ECN/PCN No.: M1384

For Manufacturer			
Product Description: Molded Power Inductor	Abracon Part Number / Part Series: ASPI-0530LR Series	<input type="checkbox"/> Documentation only <input checked="" type="checkbox"/> ECN <input type="checkbox"/> EOL	<input checked="" type="checkbox"/> Series <input type="checkbox"/> Part Number(s)
Affected Revision: A	New Revision: B	Application:	<input type="checkbox"/> Safety <input checked="" type="checkbox"/> Non-Safety

7.0 Mechanical Dimension

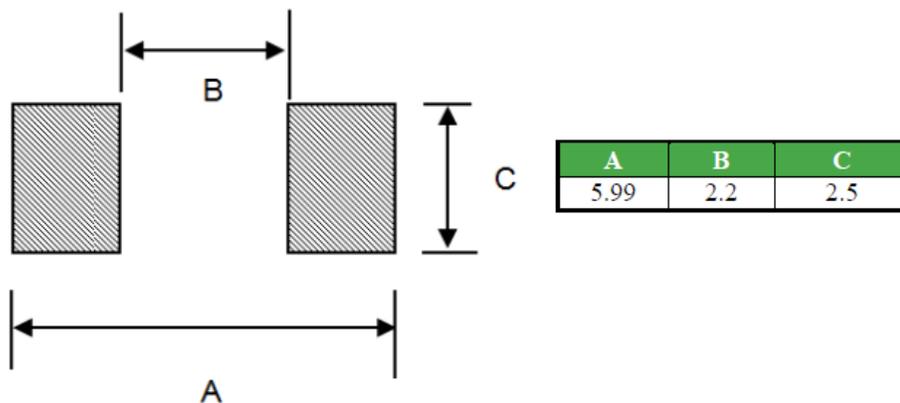
A	A'	B	B'	L	W	H max
1.0 ±0.4	1.5 ±0.1	2.0 ±0.3	2.5 ±0.2	5.60 ±0.35	5.2 ±0.2	3.0

The overall mechanical outline has changed slightly. More importantly, the recommended pad layout has changed. Design engineers must review and ensure new pad dimensions are permissible. Please review the included pad dimension analysis illustrations.

Pad Analysis for the original recommended PCB pad layout and the inductors electrodes.

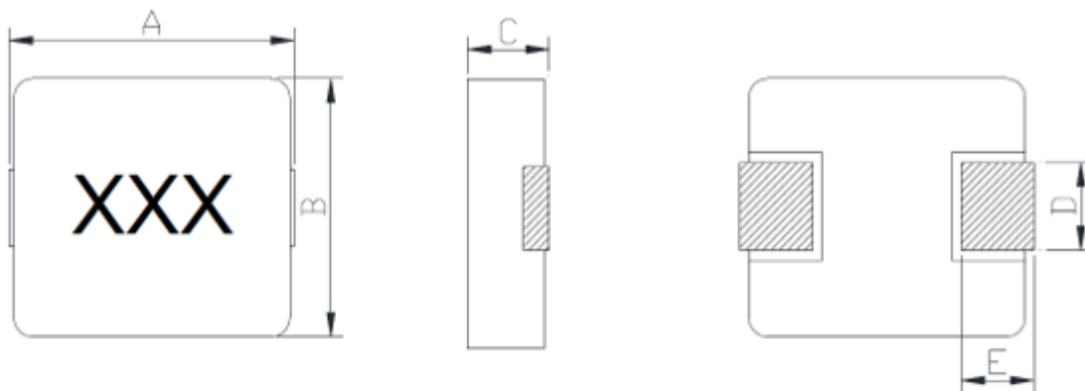
Inductor electrodes height:	<input type="text" value="2.0"/>	PCB footprint pads height:	<input type="text" value="2.5"/>
Inductor electrodes length:	<input type="text" value="5.6"/>	PCB footprint pads length:	<input type="text" value="6"/>
Inductor electrodes gap:	<input type="text" value="2.6"/>	PCB footprint pads gap:	<input type="text" value="2.2"/>
Enter a Scaling Value:	<input type="text" value="3"/>	Dimensions [mm]	
<small>(Adjust value to zoom in or out, i.e 1.00, 0.5, 3.5, etc)</small>

Mechanical Specifications

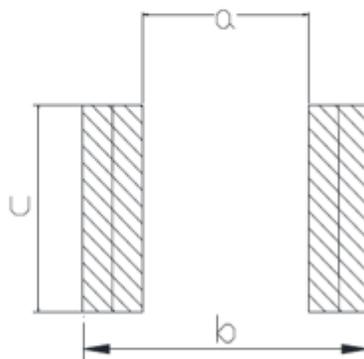
A	B	C	D	E
5.7 ±0.3	5.3 ±0.4	3.0 MAX	2.0 ±0.5	1.2 ±0.5

Pad Analysis for the original recommended PCB pad layout and the inductors electrodes of the updated package.

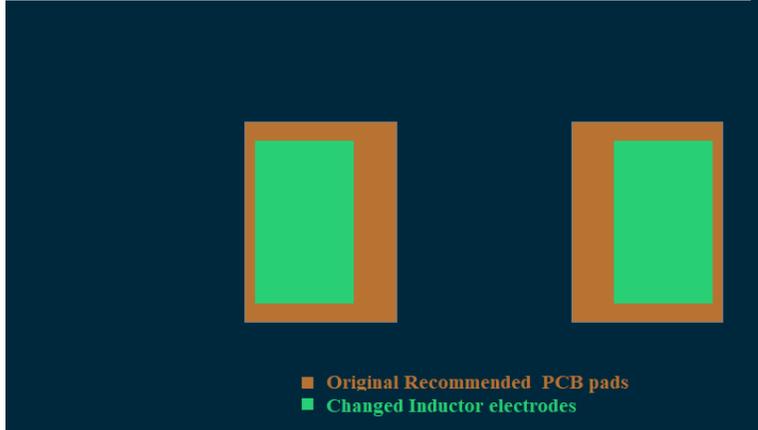
Inductor electrodes height: <input type="text" value="2.0"/> Inductor electrodes length: <input type="text" value="5.7"/> Inductor electrodes gap: <input type="text" value="3.3"/> Enter a Scaling Value: <input type="text" value="3"/> <small>(Adjust value to zoom in or out, i.e 1.00, 0.5, 3.5, etc)</small>	PCB footprint pads height: <input type="text" value="2.5"/> PCB footprint pads length: <input type="text" value="6"/> PCB footprint pads gap: <input type="text" value="2.2"/> Dimensions [mm]
--	---
